Different technical modifications and updatings on coral 65m

Here below you will find the most important modifications carried out on **coral 65m**. We ask you to carefully read all the information, necessary for your future orders. We add furthermore the updated index with all its revisions, so that you check your files and ask for the missing tables.

ref. table M0803-10 R00, pos. 43

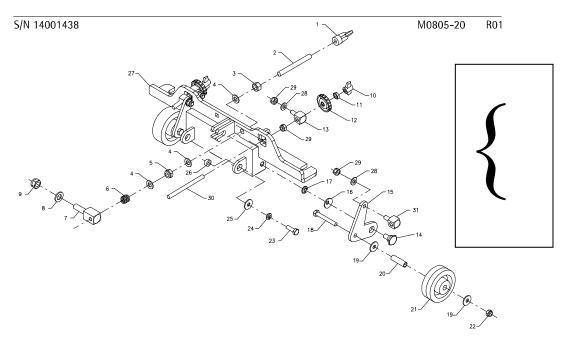
We have corrected the part number of the screw of pos. 43, which at the place of 60110401 is: 60110411. The description remains unchanged.

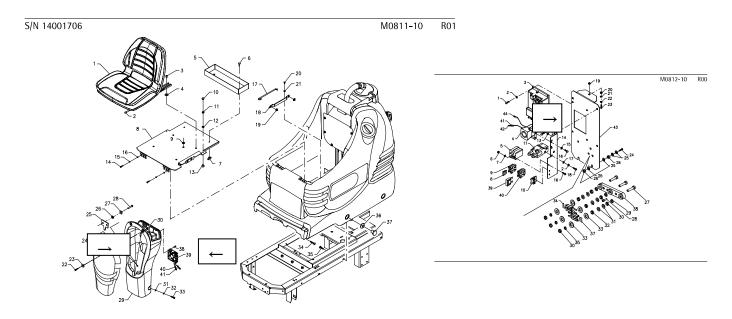
→ Starting from serial number: 14001706 dated 29/04/14 – table M0811-10 R01 and M0812-10 R00 To improve the performances of the chopper card, we have added a cooling fan. This device requires the realization of ventilation openings on the front column, on the front frame and on the electric panel. The modification can be applied also on already produced machines. The complete assembly of the fan has part number: V0812010

The assembling instructions T081208 are available.

→ Starting from serial number: 13003293 dated 02/10/13, table M0812-20 R00, pos. 5 We have replaced the fuse 62801003 of 10A with one of 15A having part number 62801501. This fuse is assembled on the check card of the functions, pos. 5.

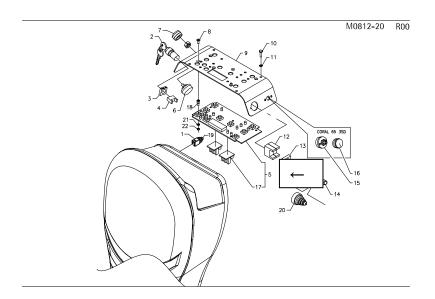
We enclose the modified electric diagram, Cre0812-30 R01 (pos. F5).

14001760 dated 08/05/14, table M0811-10 R02 and table M0812-20 R01

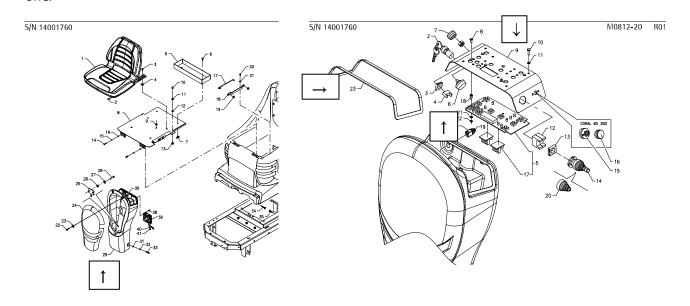
The front covering (pos. 29) and the control panel has been replaced to fit the sealing gasket.

The housing of the control panel (pos. 9) has been enlarged to permit the assembly of a sealing gasket (pos. 23). The modification requires an intervention on the mould of the front covering 20611010 which cannot be supplied anymore as a spare part for the produced machines. In case of spare parts requests, it is necessary to supply the new front covering with the new control panel and the gasket, informing us about the colour of the covering. The label of the control panel remains unchanged.
